**A Resolution to Approve a Proposal from Williams and Works, Inc., for Engineering Services for the Well No. 11 Wellhouse, Water System Tie-in, and Permitting.**

**SUBJECT:** Aquifer Test Review – City of Grand Ledge, Type 1 Well, TPW-11, Oneida Township, Eaton County, WSSN 2770

SUBJECT: City of Grand Ledge – Aquifer Analysis Review

Figure 1 W&W graph of time-drawdown day at TPW-11, OW-1, and OW-2 showing recharge-type events at 40 and 250 minutes

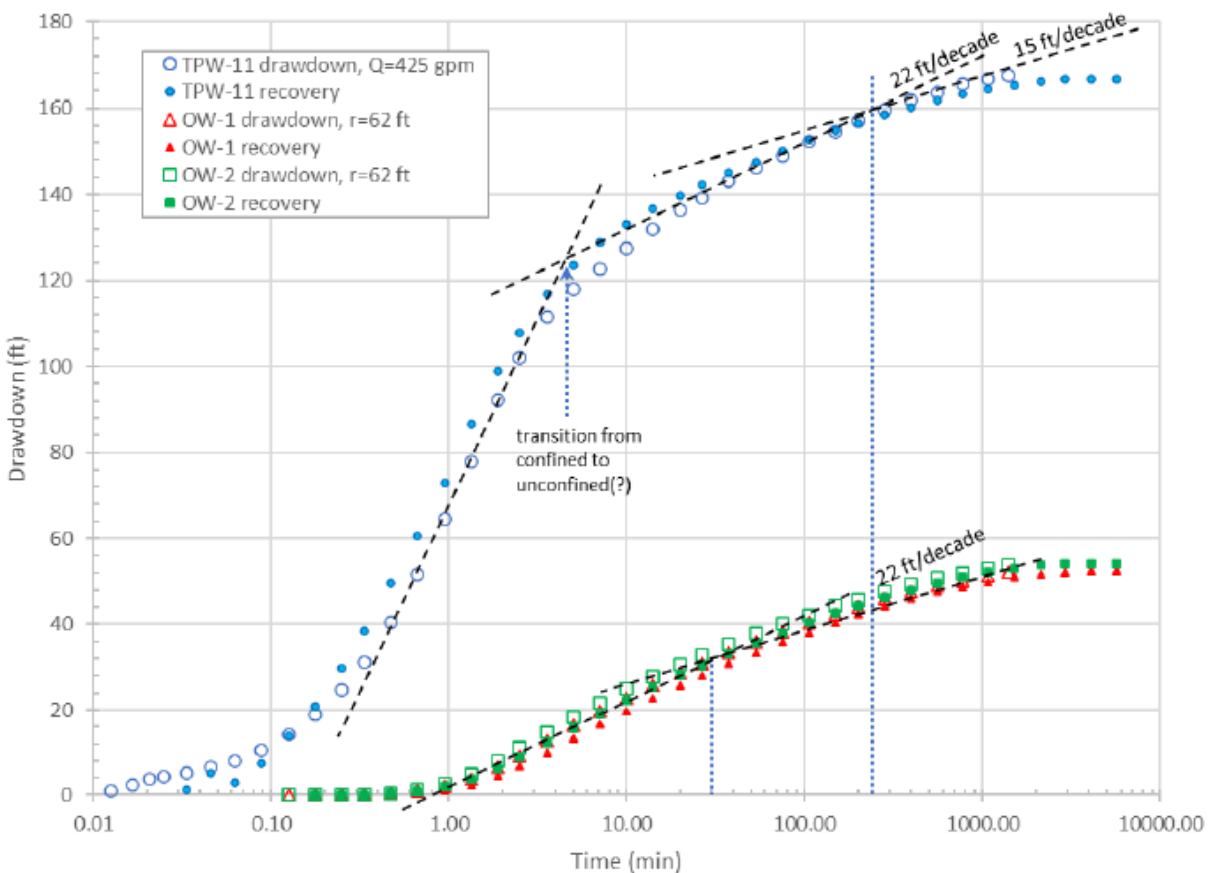
Two distinct "recharge-type" breaks in the drawdown curves, occurring at approximately 40 minutes and 250 minutes (figure 1). Several potential explanations for these breaks were considered in the report, with the most plausible being leakage from the Grand River over a broad reach of the river. Leakage would align with the observed widespread drawdown propagation and gradual "leaky" behavior in later times.
